**APPEAL OF 2101 CONNECTICUT AVENUE
COOPERATIVE APARTMENTS, INC. FROM A
DETERMINATION OF THE ZONING
ADMINISTRATOR PERTAINING TO A PROPOSED
REAR ADDITION TO 2012 KALORAMA ROAD,
NW, WASHINGTON, DC 20009
SQUARE 2537, LOT 0150 (R-5-B)**

AND REQUEST FOR STAY

Re: Zoning PDRM – 2012 Kalorama Road, NW – Subject Property

ZONING ANALYSIS 2012 KALORAMA RD, NW

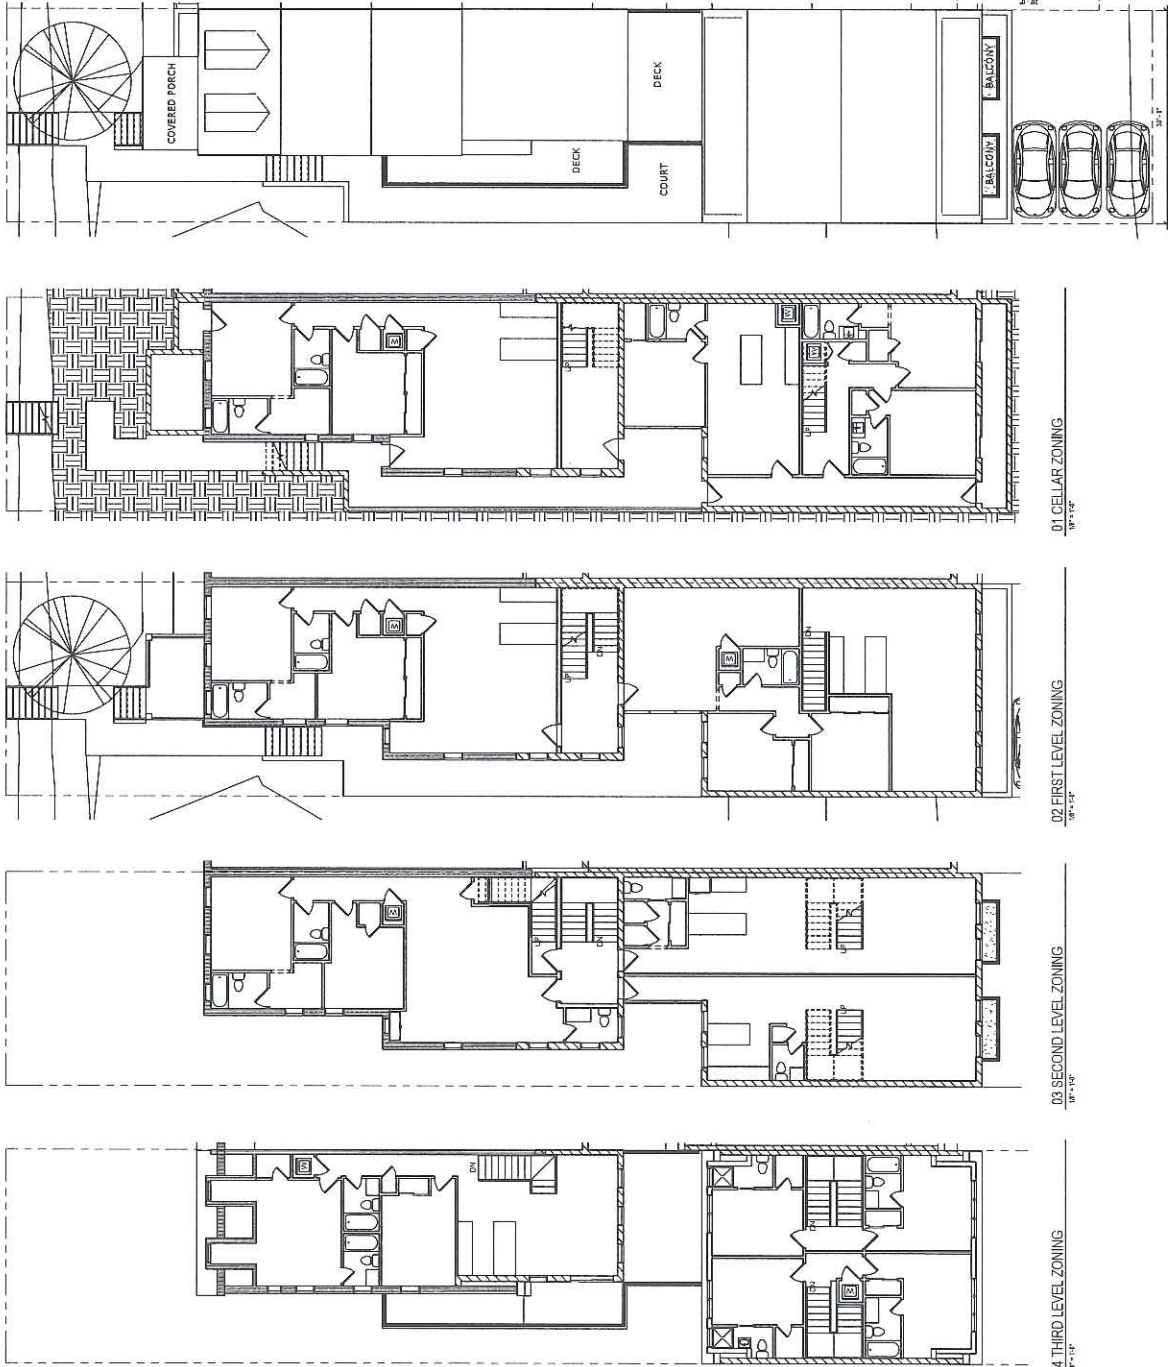
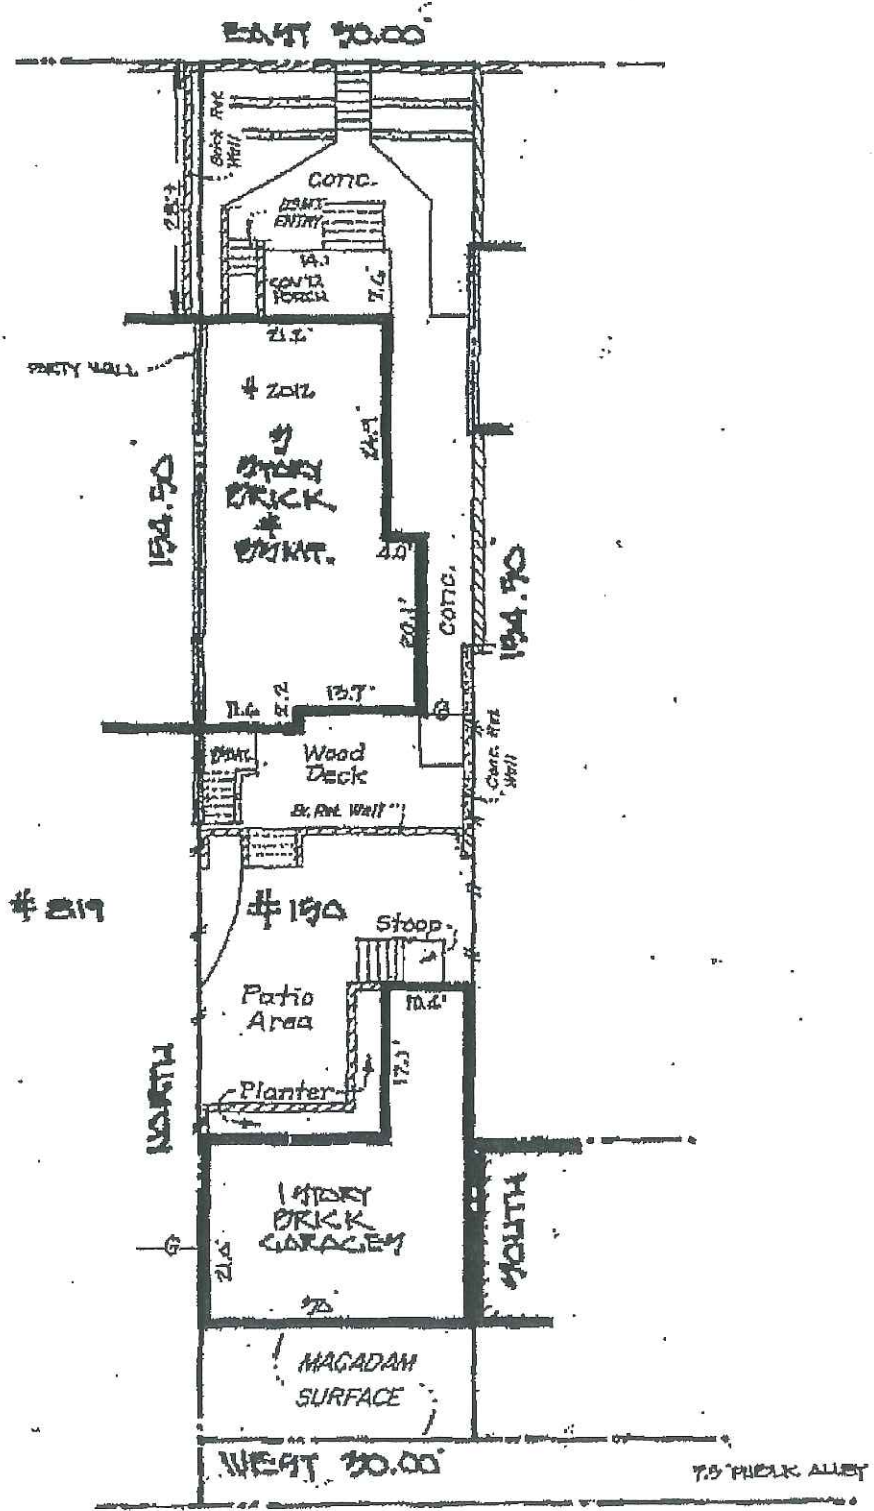
As stated above, the Determination includes by reference a “Zoning Analysis.” However, a review of the Zoning Analysis establishes that it includes mistakes and does not contain information necessary for the Zoning Administrator to make his determination.

for the Zoning Administrator to determine the Project's compliance with the Zoning Regulations. A review of the Zoning Analysis establishes that this document fails to meet all of these requirements. In particular, the Zoning Analysis lacks almost all dimensions, an identification of the front or rear portions of the property, notation of heights, a unit count or even an orientation to true North. Rather, the Zoning Analysis appears to be conceptual designs accompanied by unsupported conclusions that the Project satisfies the FAR and lot coverage requirements. Such a document does not allow for a determination of Code compliance.

Exhibit "C"

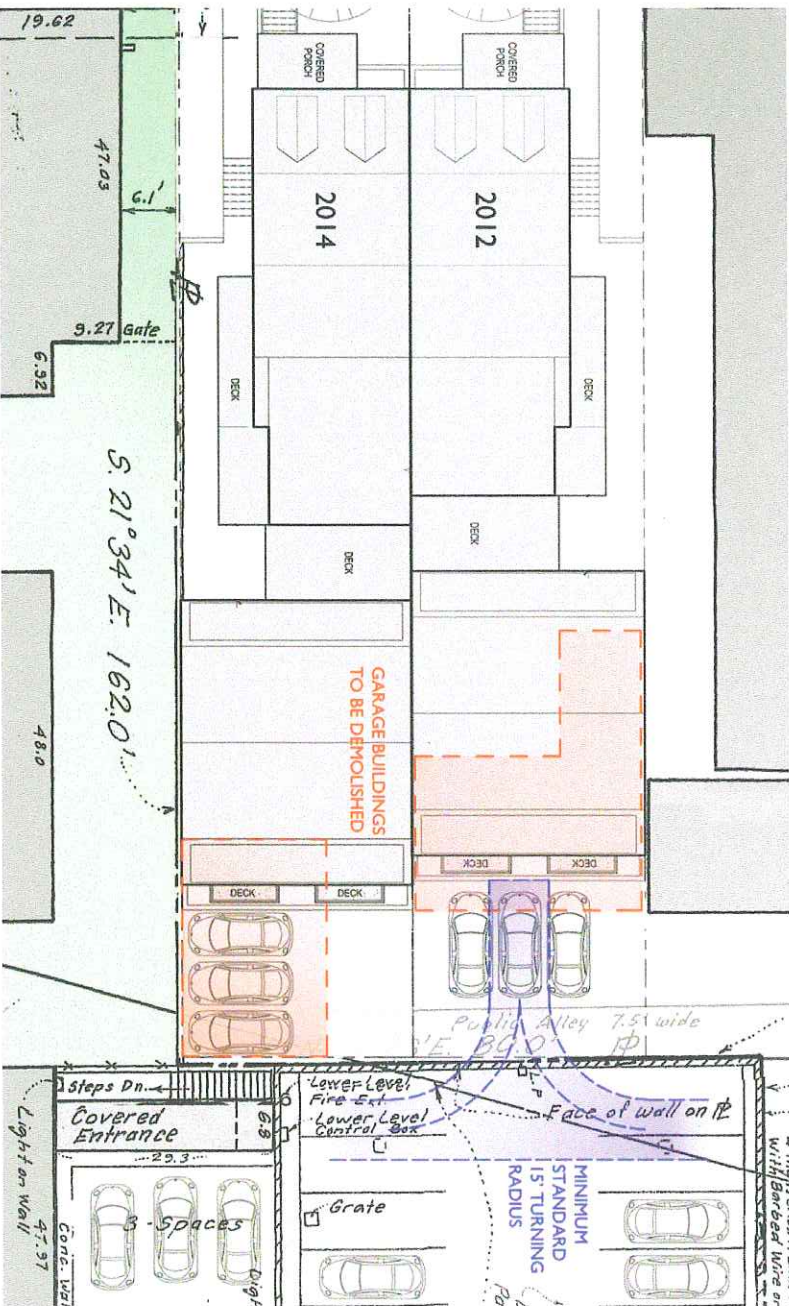
- Ingress/Egress impossible for vehicles and passengers.
- Will not conform to the Zoning Administrators requirements.
- Not legal spaces.
